CCPS RFP#24-15 – NORTH EAST MIDDLE/HIGH SCHOOL REPLACEMENT PROJECT

ADDENDUM #03

This addendum is to address Bid RFIS, contract drawings, and specification modifications as noted below. Proposers and related parties will be responsible for reading and understanding all documents, the scope of work, addenda and all related solicitation documents issued. These documents will become attached to and part of the solicitation and award of bid contract.

ITEM No. 4 **CONTRACT DRAWINGS AND SPECIFICATIONS – Changes and clarifications dated 03/25/2024**

H9 GEOTHERMAL BLDG SOUTH - ROOF PLAN
1/8" = 1'-0"

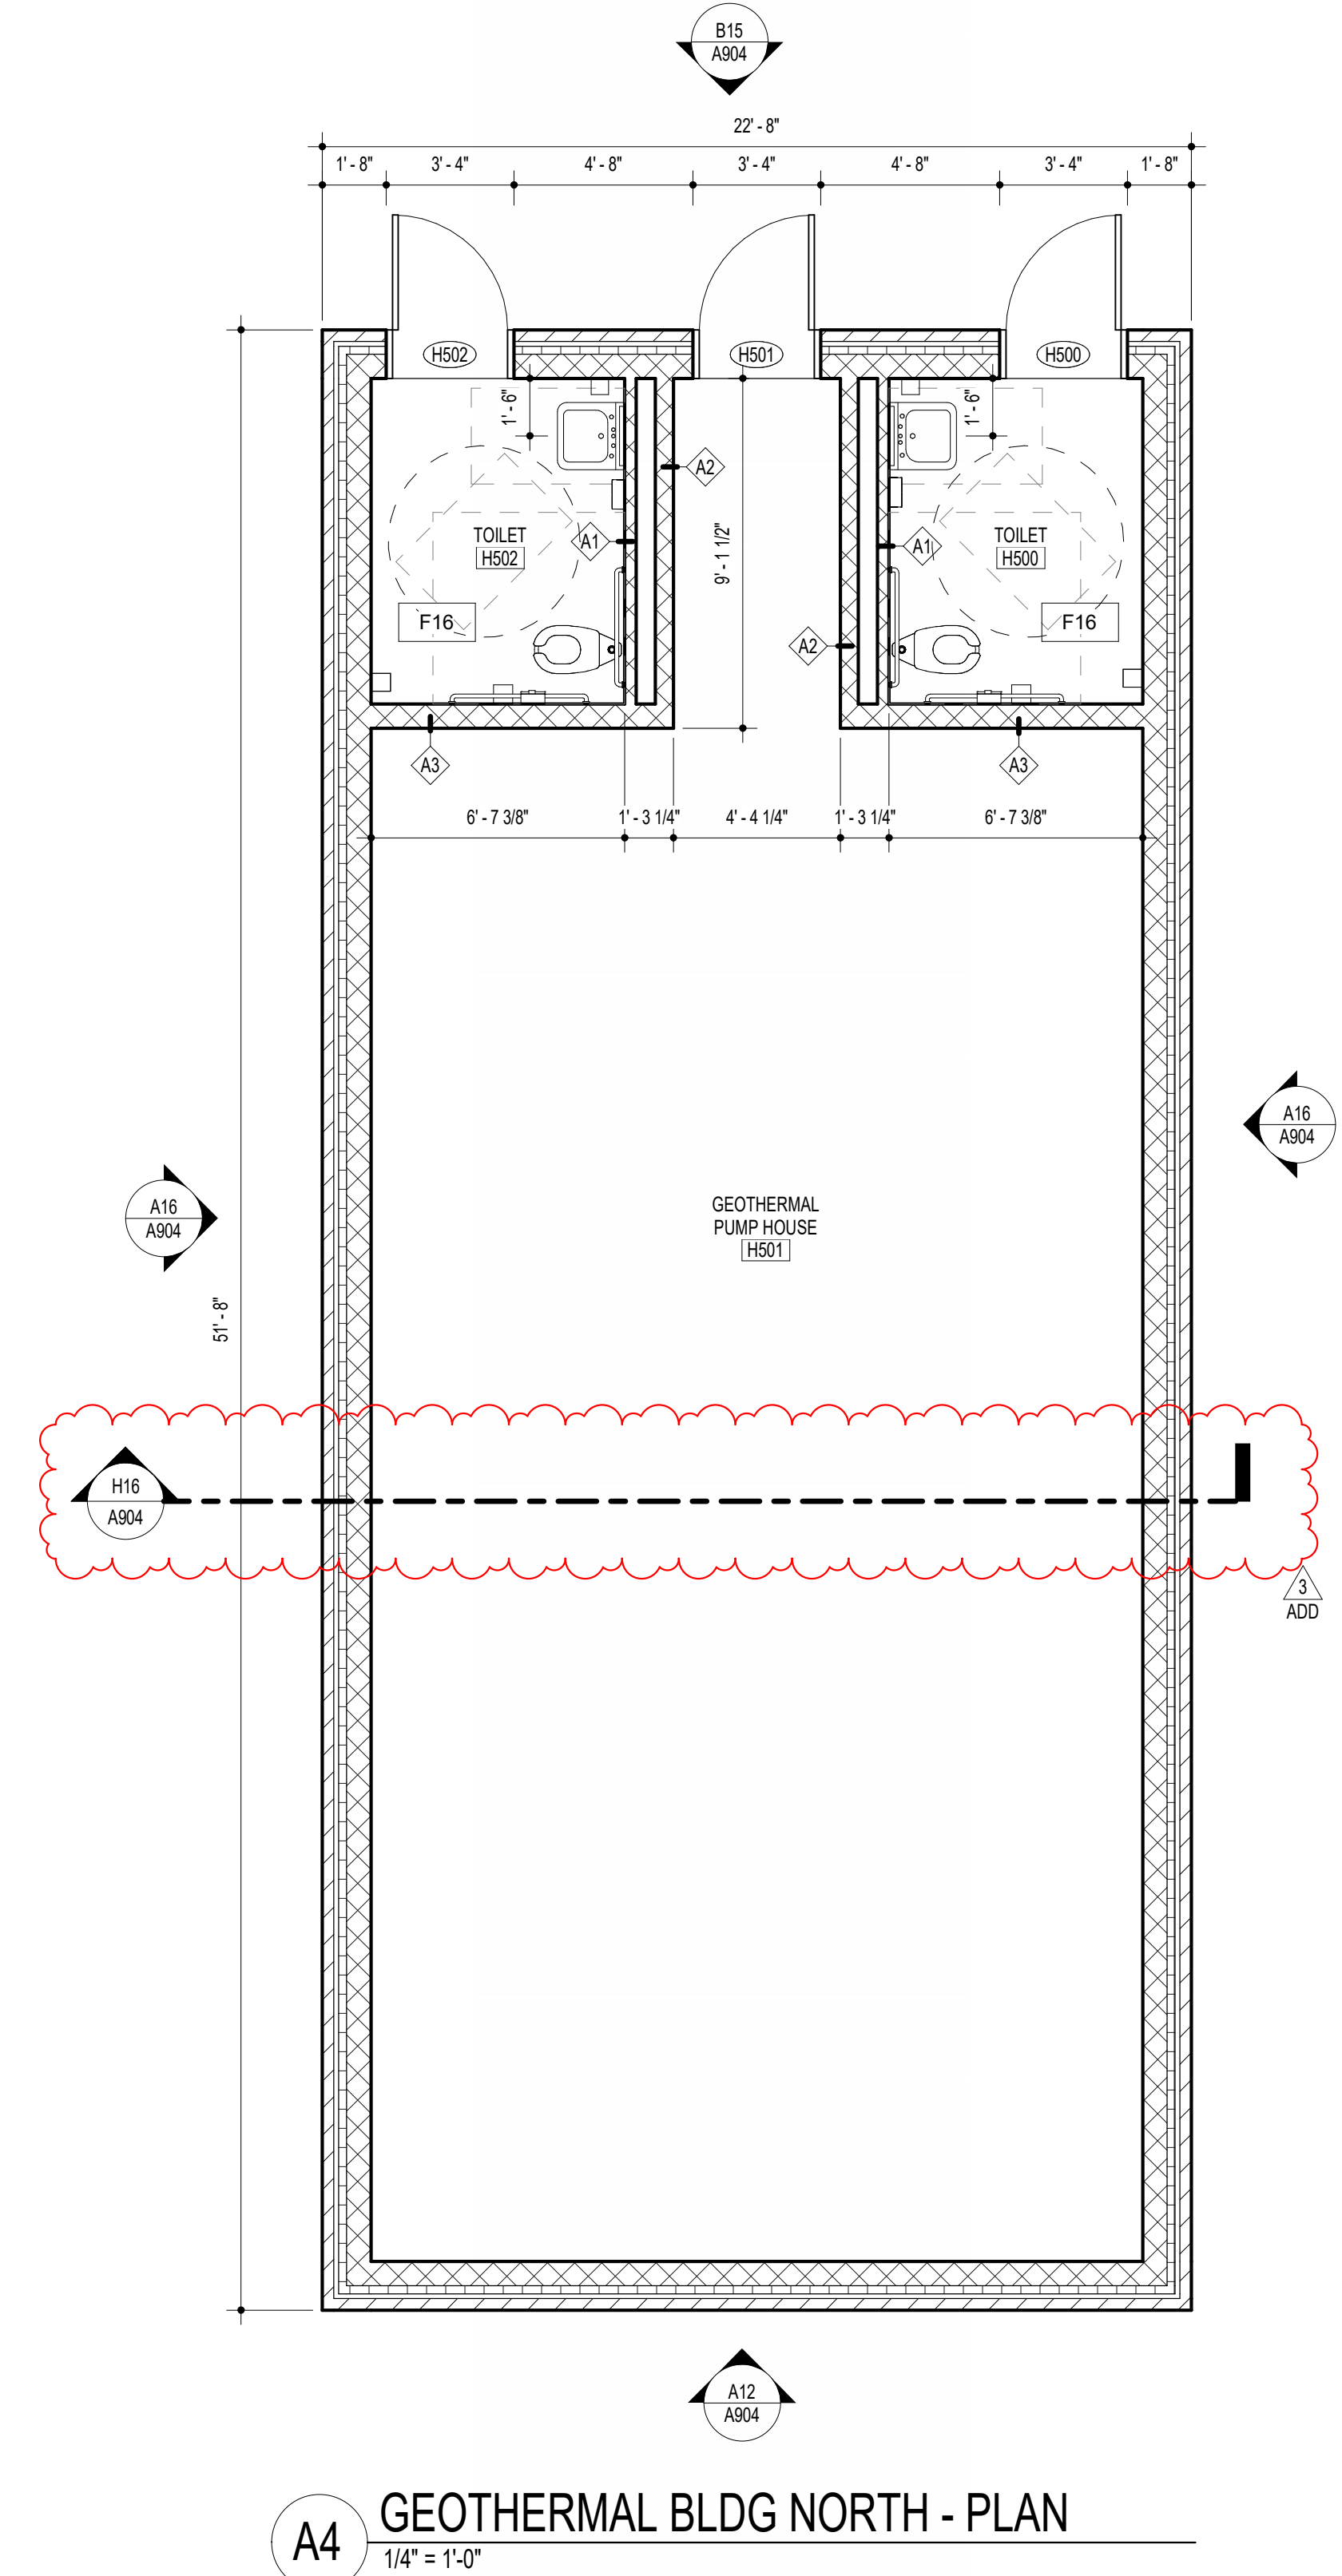
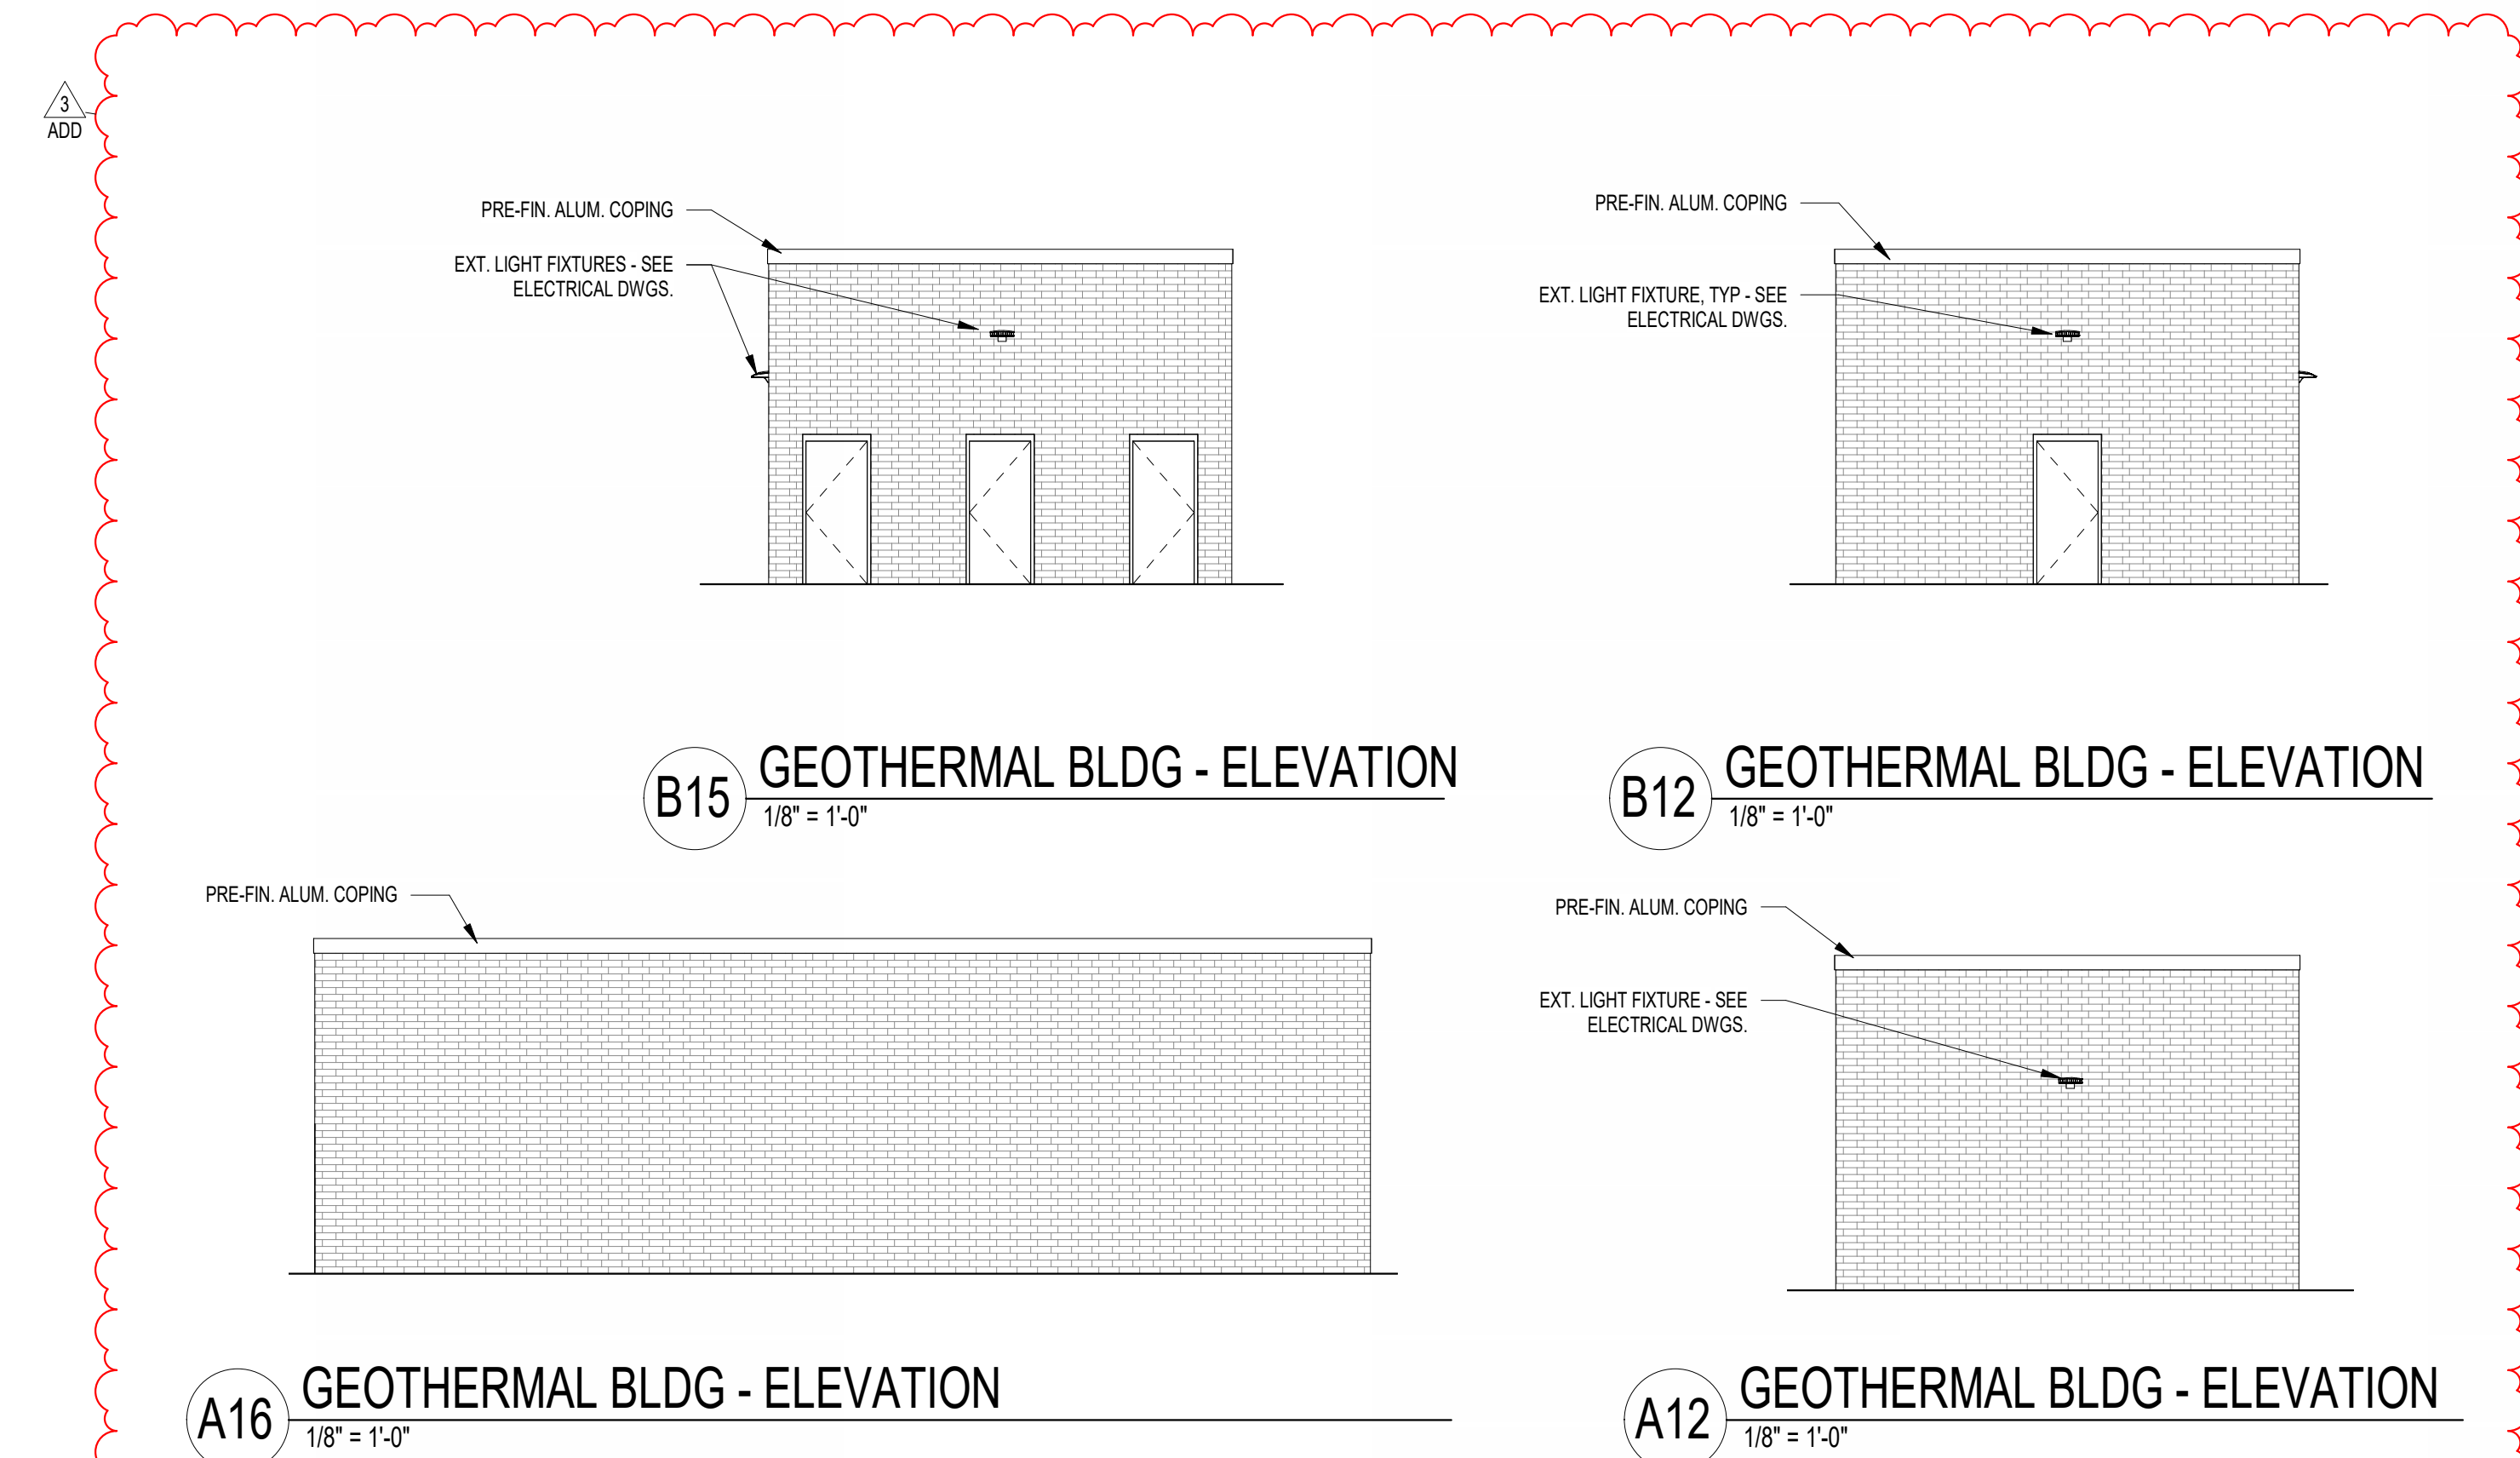
Revise sheet A904 per attached reissued sheet:

ADD Detail H16 GEOTHERMAL BLDG – SECTION and associated references (Details A4 and A9).
ADD Miscellaneous notes to GEOTHERMAL BLDG Elevations (Details A12, A16, B12, and B16).
ADD Note to Detail H9 GEOTHERMAL BLDG SOUTH – ROOF PLAN.
